Access Compliance Report Public Rights-of-Way (Curb Ramps)

Main Street: NORGROVE_LN Cross Street: COLERIDGE_DR Location: W

ADA ID: RPAT211202133607 Ramp Type: Type 1 - Perpendicular Diagonal Initial Pass/Fail: Fail Overall Compliance: No Severity Score: 4

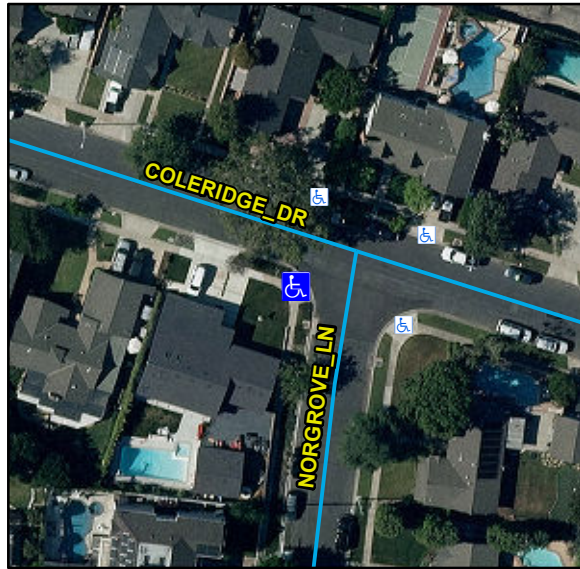
R304.2.2, R204.3, R304.5.1, STD 1115

Remove & Replace Curb Ramp With Two New Directional Ramps or Equivalent.
